Notice

Category : Multi-media Projector

Model : PLC-XF60

REFERENCE NO. SM5110680-01

(1) Servicing when the projector provides a Resistor Board on the Power Box.

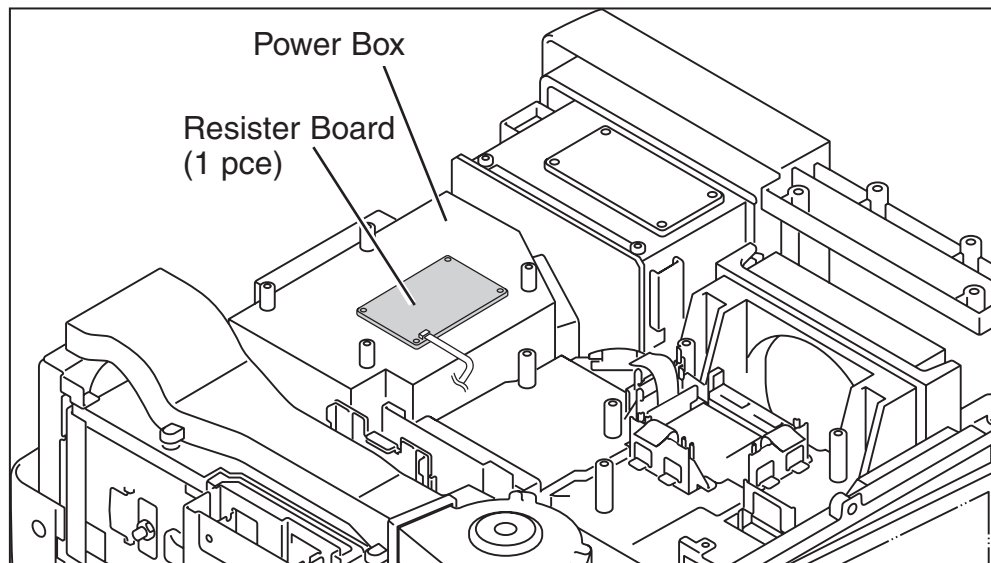
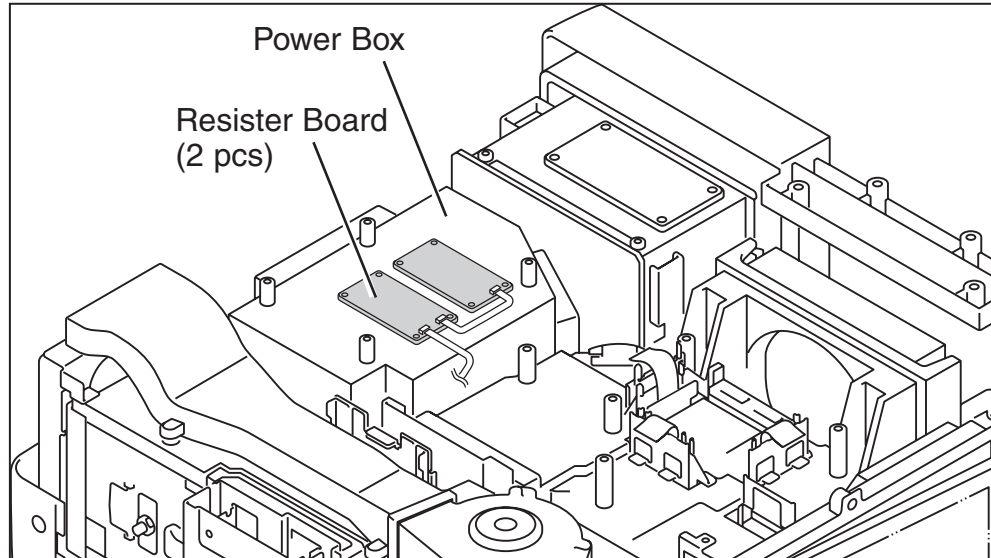
Do not replace Power (DC) Board or Power1 (AC) Board respectively. They must be replaced together even if other one is not defective. There are two type of Resistor Board. In each case, replace them together.

As the supplied board assembly contains the following parts and board, replace whole the board and parts. After replacement, the Resister Board is not necessary to install.
